VALUE ENGINEERING TEAM STUDY REPORT

NEW BEDFORD HARBOR DREDGING EPA SUPERFUND PROJECT

DOD SERVICE: USACE
CONTROL NO: CEMVN-VE-00-05
VALUE ENGINEERING OFFICER: Bill Herland

Value Engineering Study on the
**NEW BEDFORD HARBOR DREDGING
CDF "D"
EPA SUPERFUND PROJECT
NEW BEDFORD, MASSACHUSETTS**

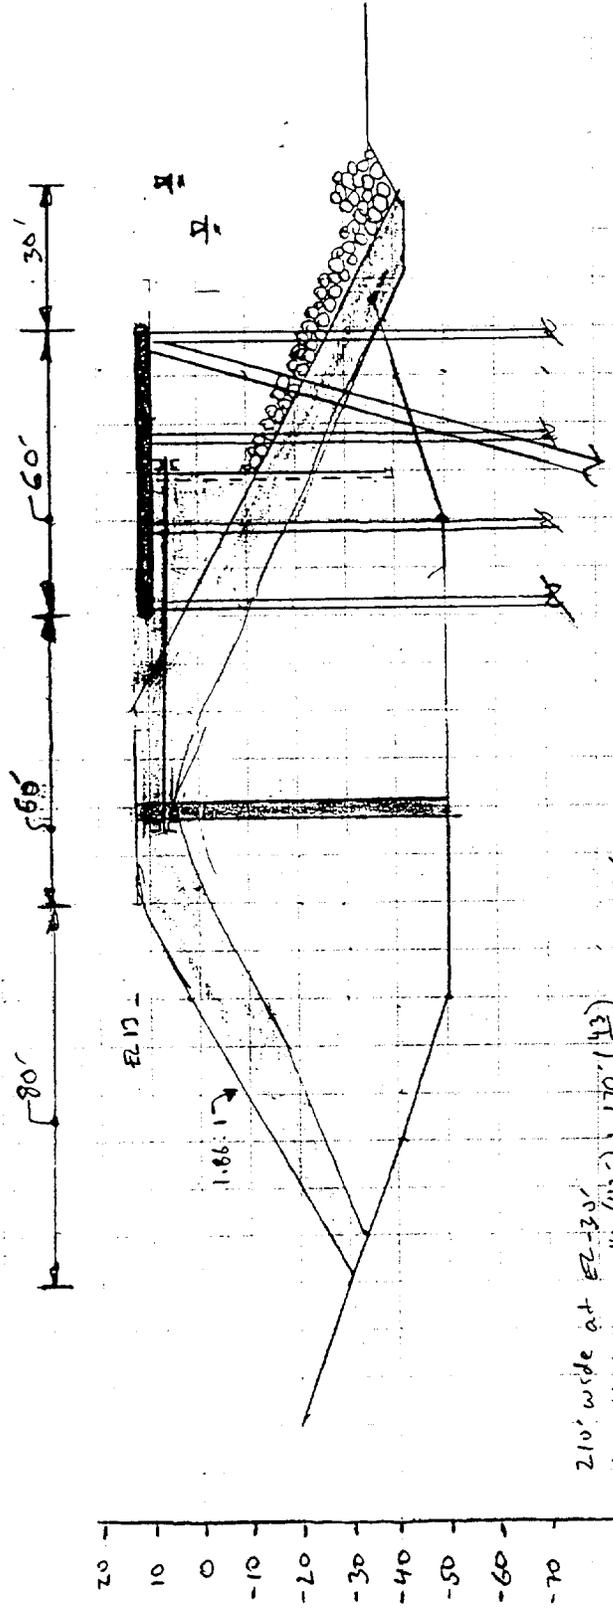
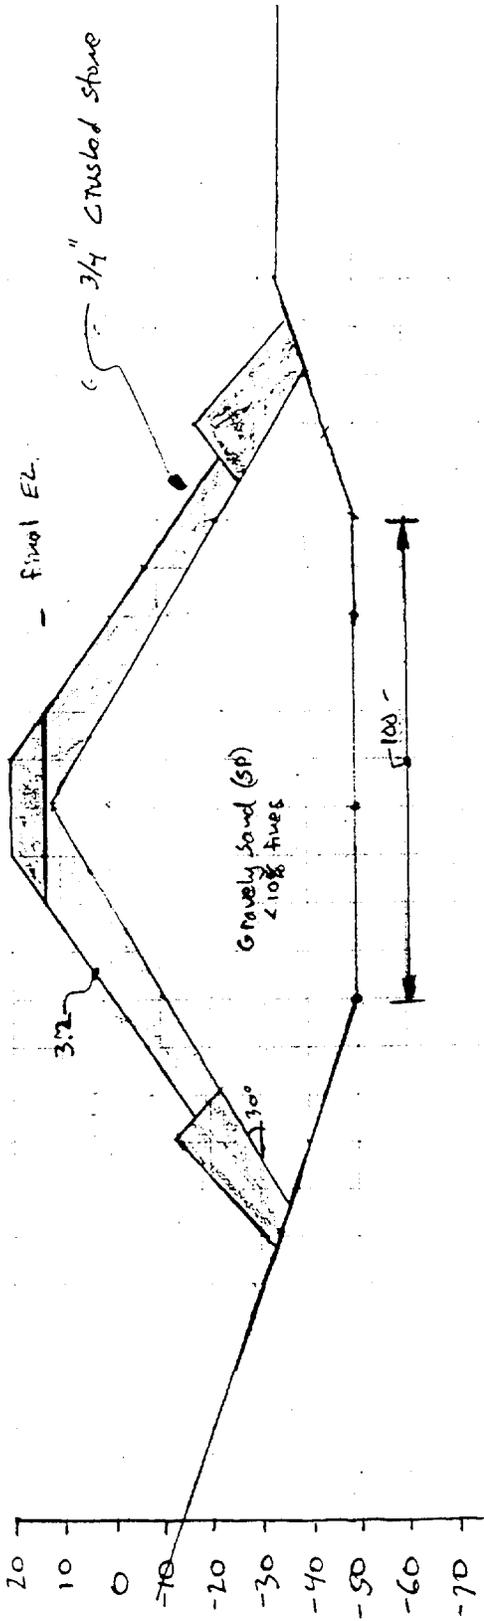
The current design constructs the CDF "D" dike using steel pile cells (See Drawing No. 1 and Appendix E).

Construct the CDF "D" dike using sand made available from dredging and other nearby projects. A sand containment dike would have either a vertical cutoff wall or place a geomembrane on the inside slope of the disposal area (See Drawing No. 2). Excavation of unsuitable materials under the dike would still be required. Fill would be compacted with terra-probe (or similar device).

DRAWING NO. 2

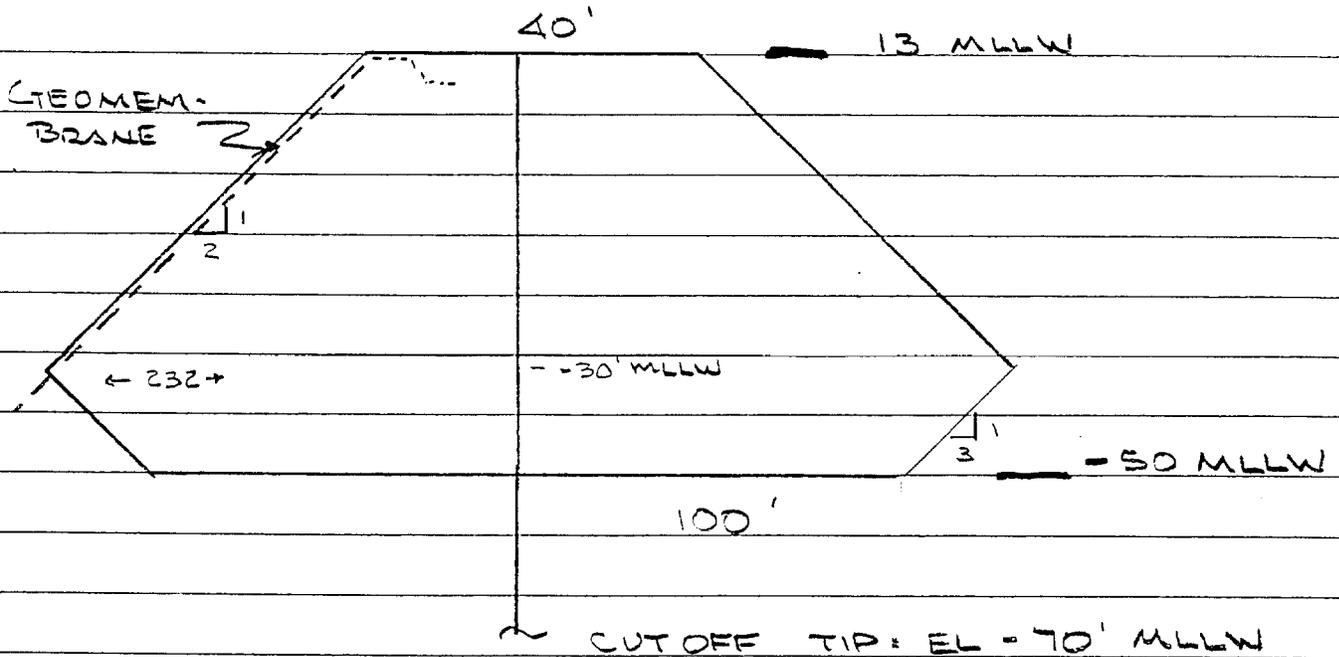
210' wide at EL -30'
 Avg Height = $\frac{40(40) + 170(12)}{210} = 25.6'$

100' wide @ EL -50 Avg Height = $\frac{40(23) + 60(53)}{110} = 51.8'$

DRAWING NO. 1

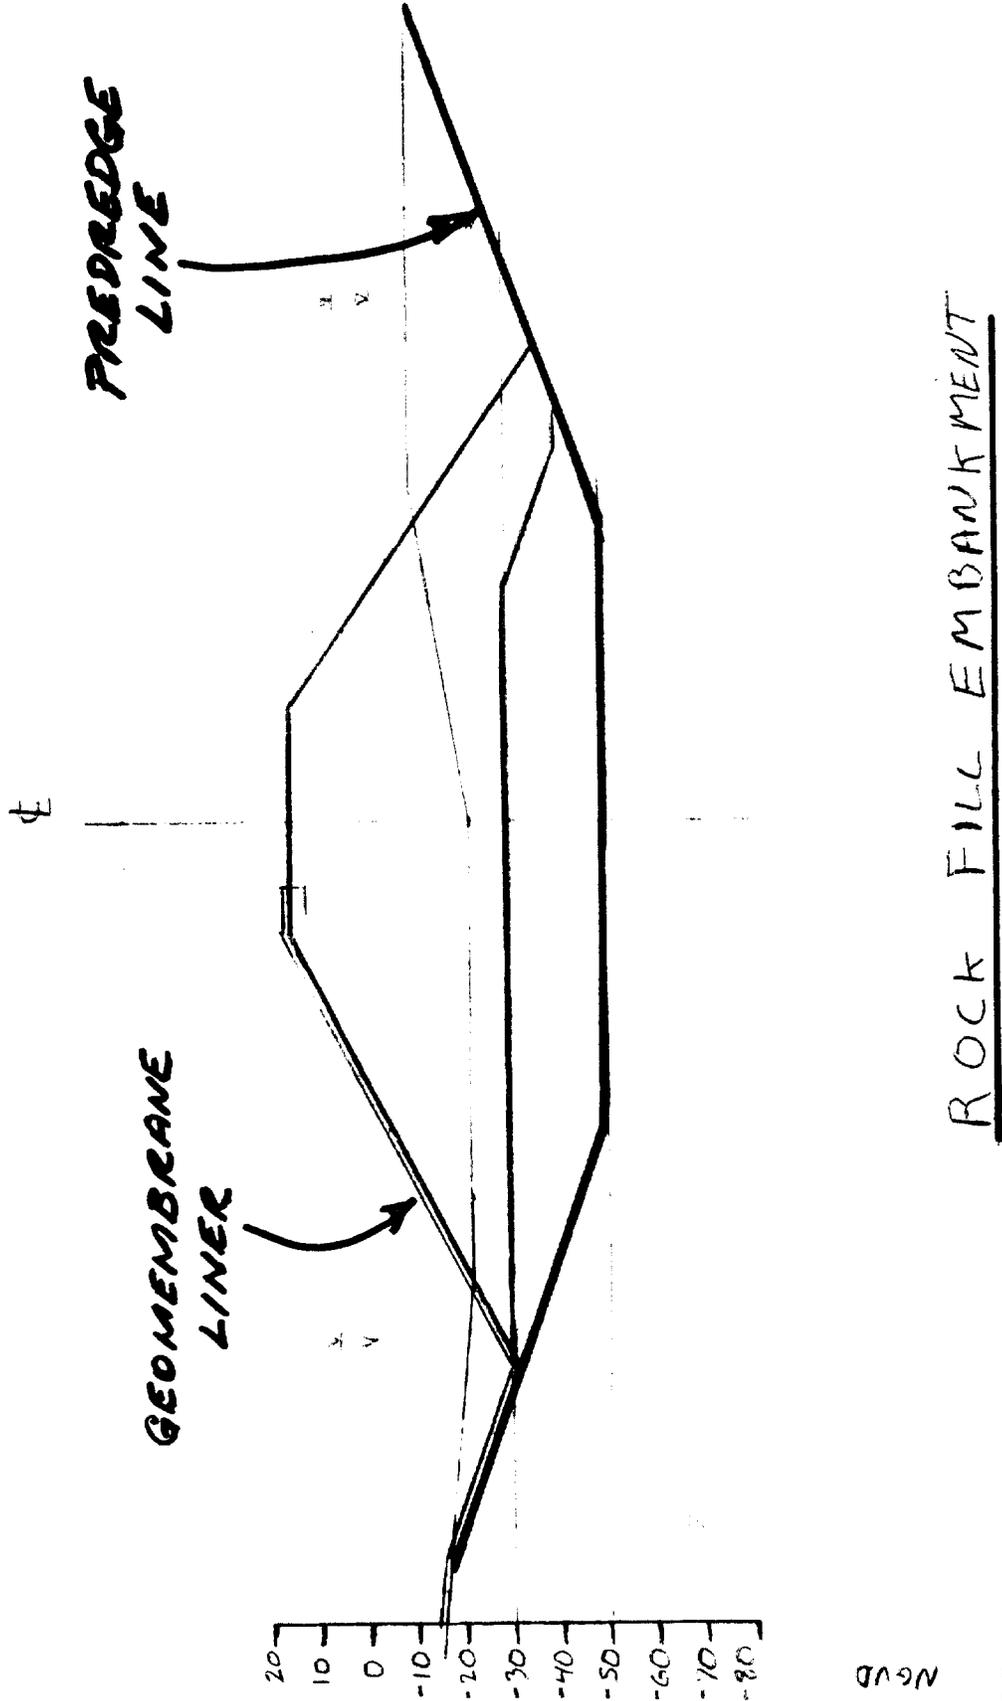
Cellular sheet-pile bulkhead with berms and cutoff wall (See Drawing No 1 and Appendix E).

- Pre-dredge to remove unsuitable soils
- Back fill with granular fill
- Densify existing sand and fill using Terra Probe or Vibro-compaction
- Drive steel sheeting
- Backfill and compact cells working from completed cells
- Install cutoff wall
- Construct wharf on berm

DRAWING NO. 2

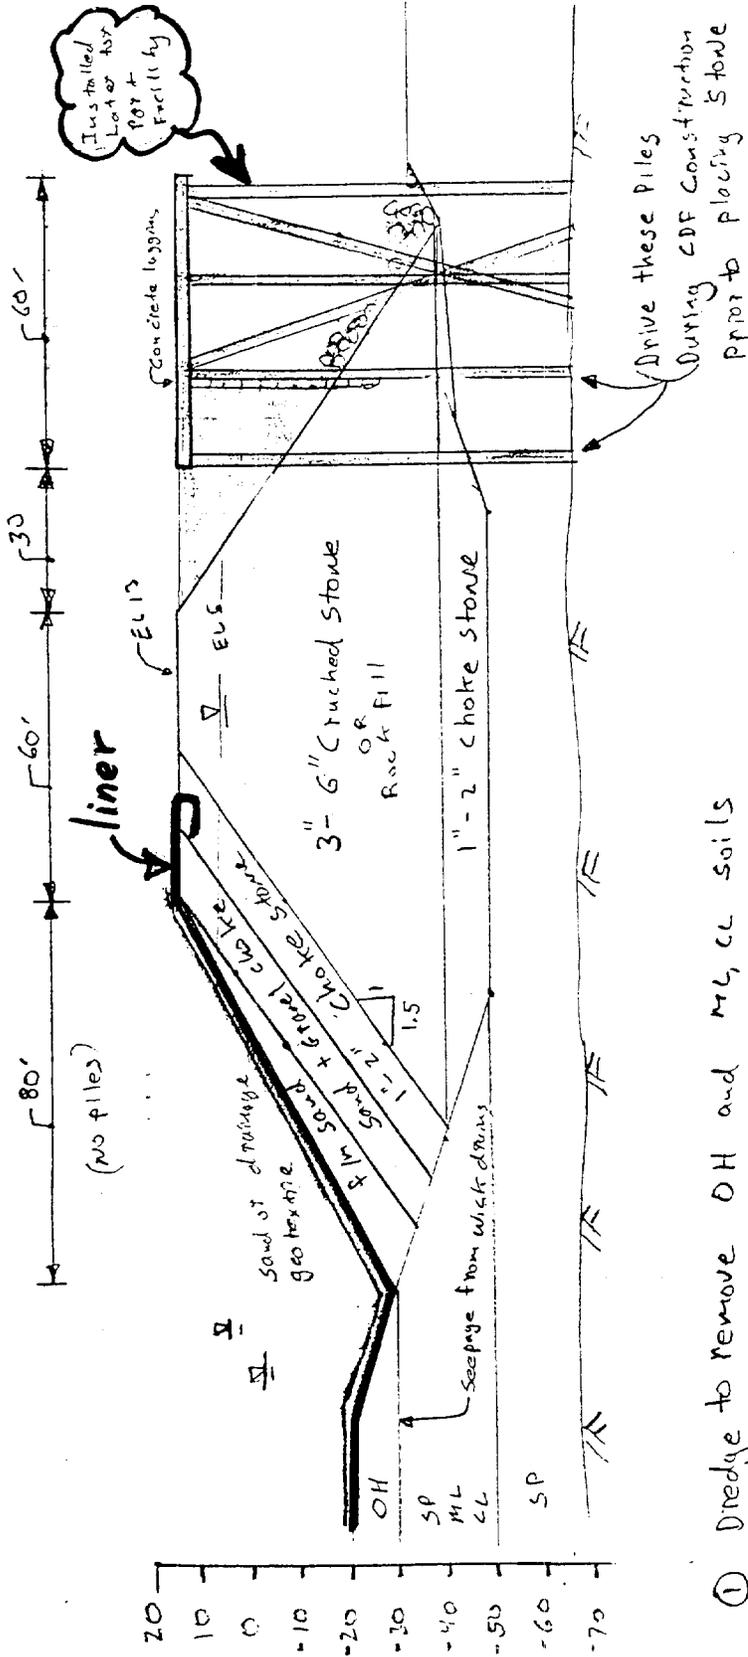
Rock fill/sand embankment with liner on inside berm (See Drawing Nos. 2 and 3).

- Pre-dredge to remove unsuitables – drive wharf piles
- Working from land, end-dump rock fill to construct embankment
- Compact rock fill in lifts above the water table
- Working from top of embankment place gravel filter and sand layers with clam shell
- Install geomembrane liner – cover with sand
- Build wharf and retaining wall (concrete logging behind deck pier)
- Place Class I armor at toe

DRAWING NO. 3

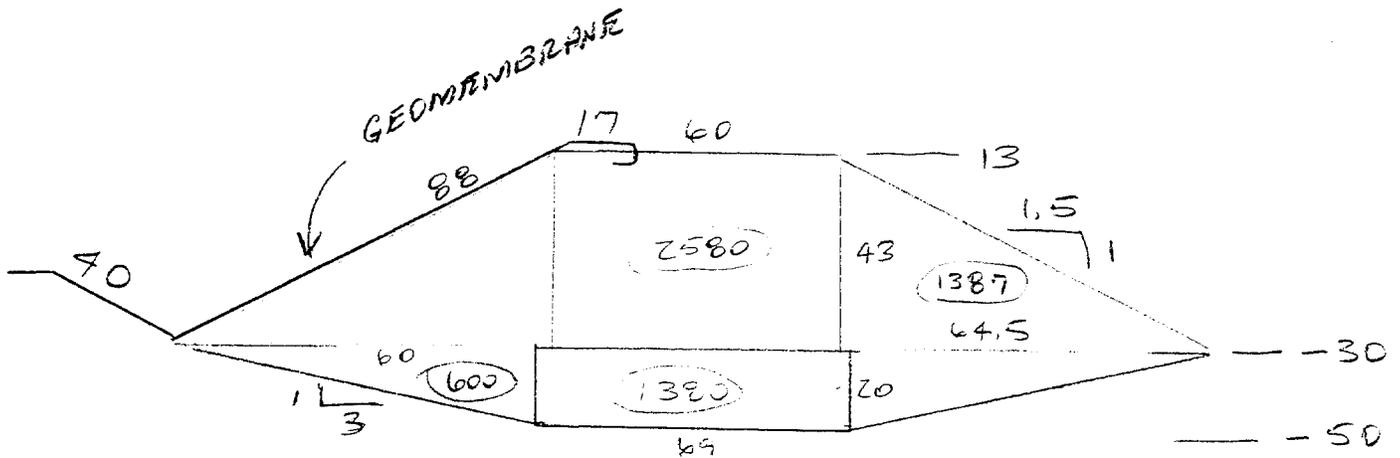
- ① Dredge to remove OH and ML, CL soils
- ② If necessary vibrate compact lower sand
- ③ Install piles indicated working from a barge
- ④ Place 3'-6" crushed stone for embankment by end dumping from land. Place choke stone layers by clamshell from land and work into place
- ⑤ Install Geotexture. Clamshell place sand over geotexture to hold in place and to provide drainage layer.
